GENWAL™
RESOURCES, INC.

Re: Genwal Resources, Inc. C/015/032
C16-003 NOV #21175 Response Task ID No. 5174

Application for Permit Processing Detailed Schedule of Changes to the MRP

C16-003 NOV #21175

REV: 19	ACAD: 5-3 REV19
DATE: 04-29-16	BY: PJW
SCALE: AS SHOWN	PLATE #: 5-3

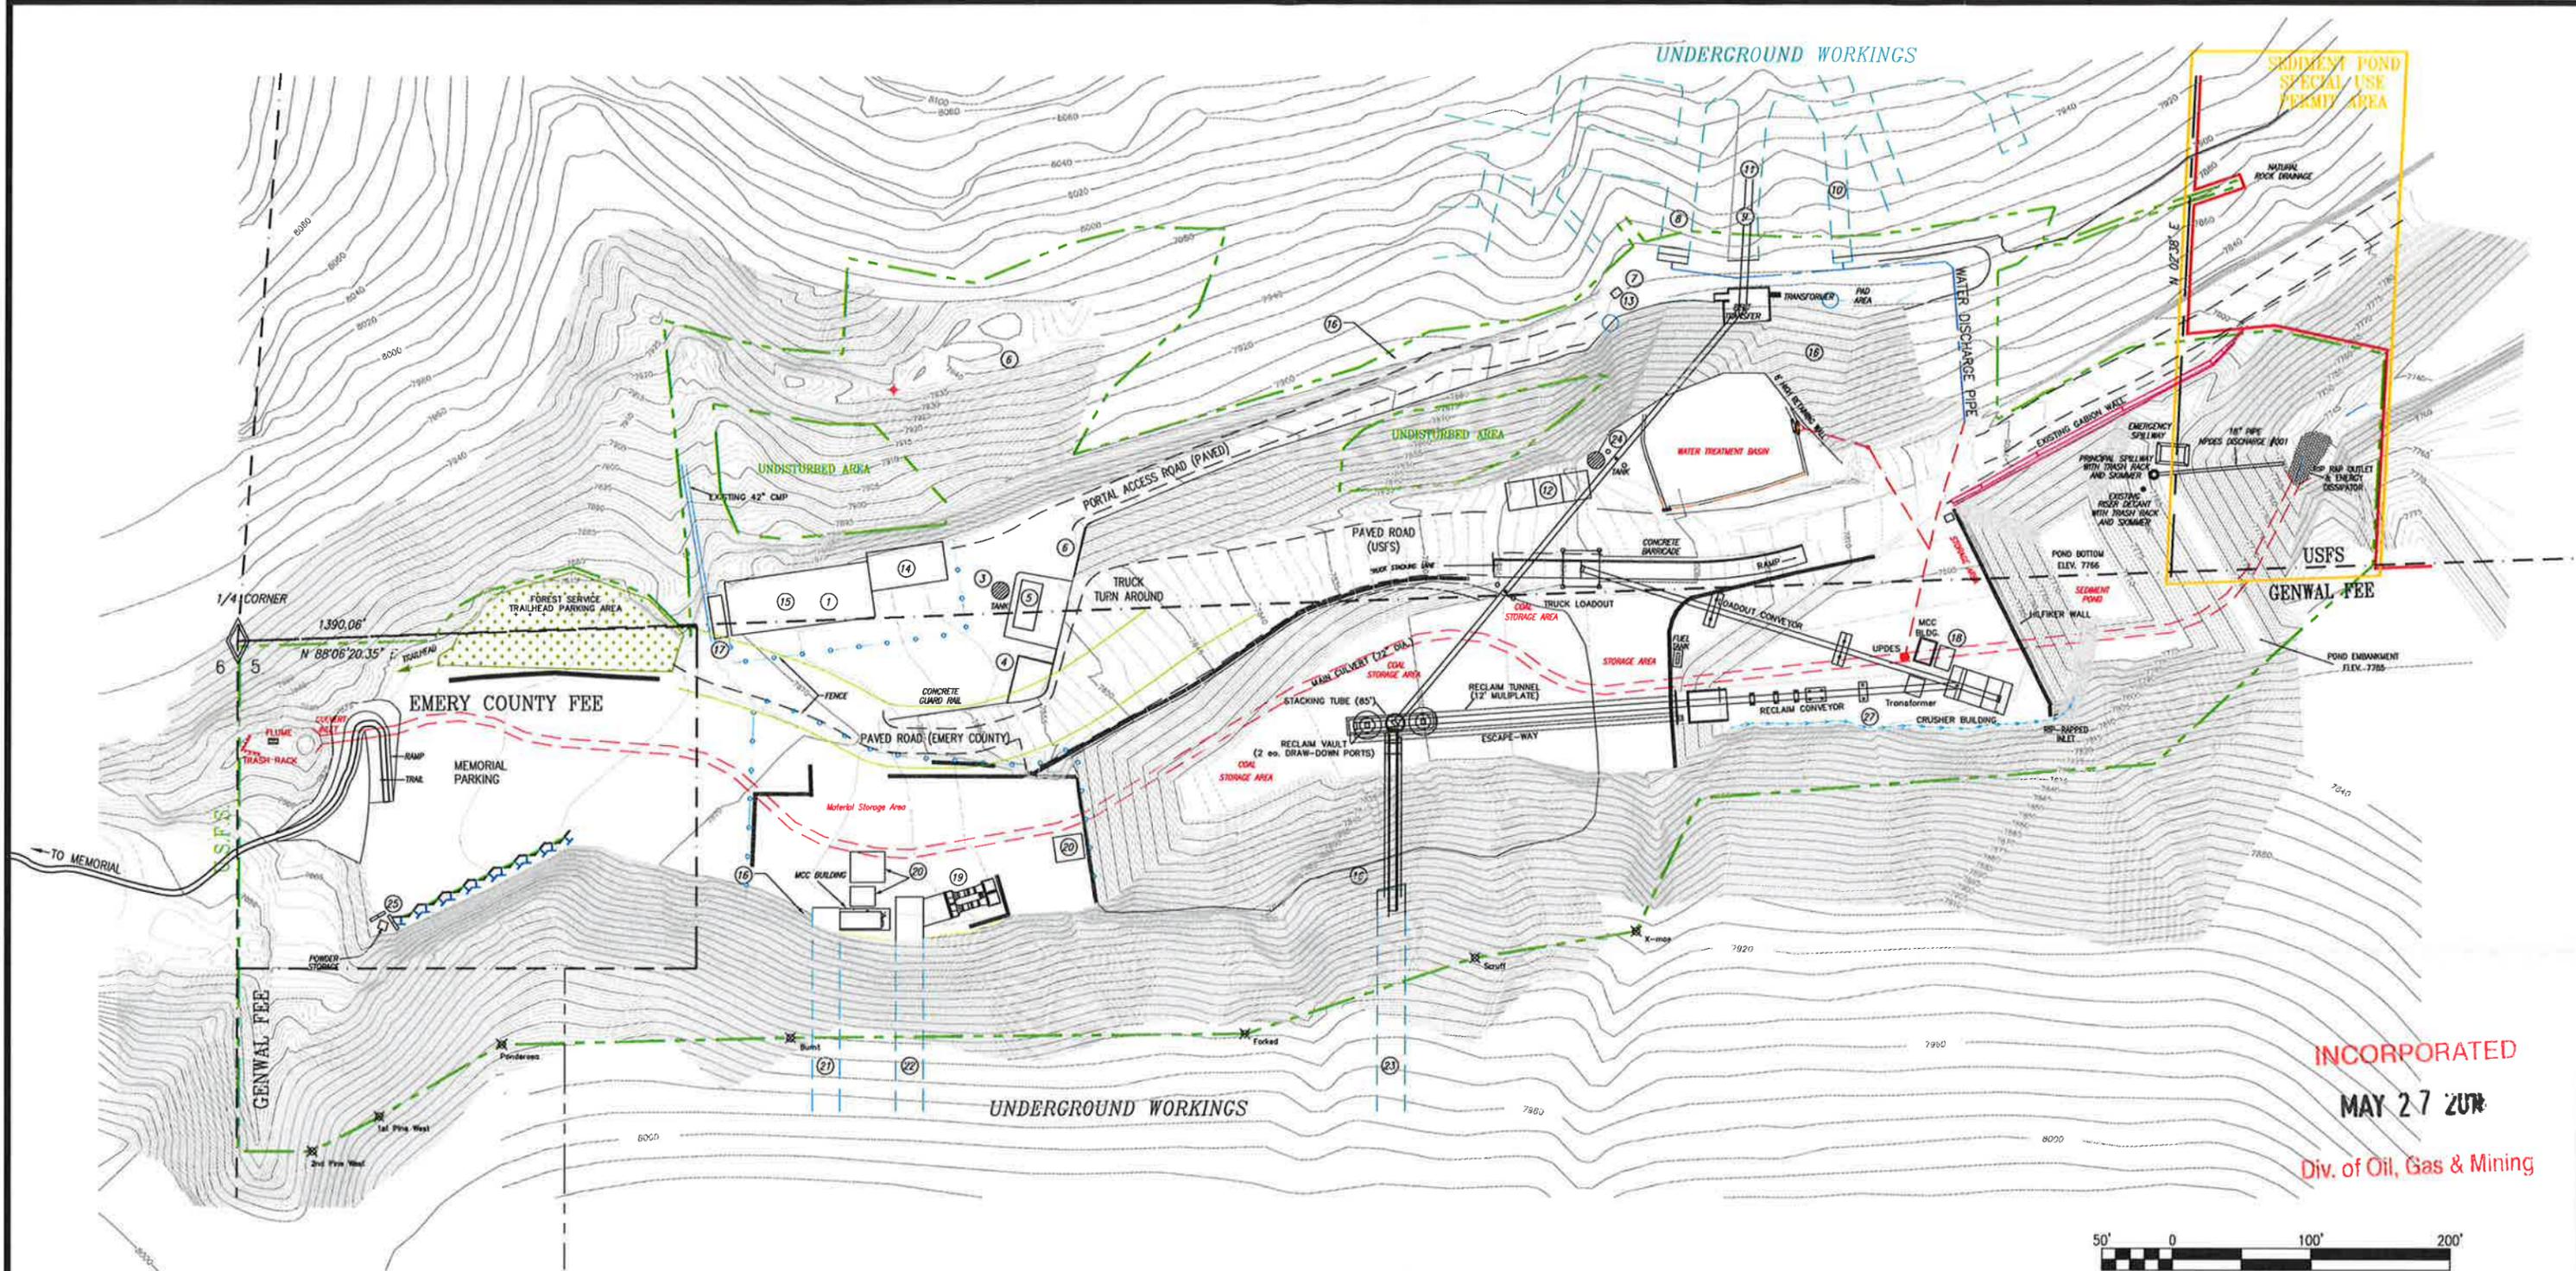
- (e) As a security measure, a 6' chainlink fence (located on plate 5-3) with barbed wire along the top will be installed around the perimeter of the main office building to deter trespassing by unauthorized persons, at any time during cessation it is deemed necessary to protect the property. Iron gates will also be installed to protect all doors on the main building and treatment plant building to keep unauthorized persons from entering the buildings.
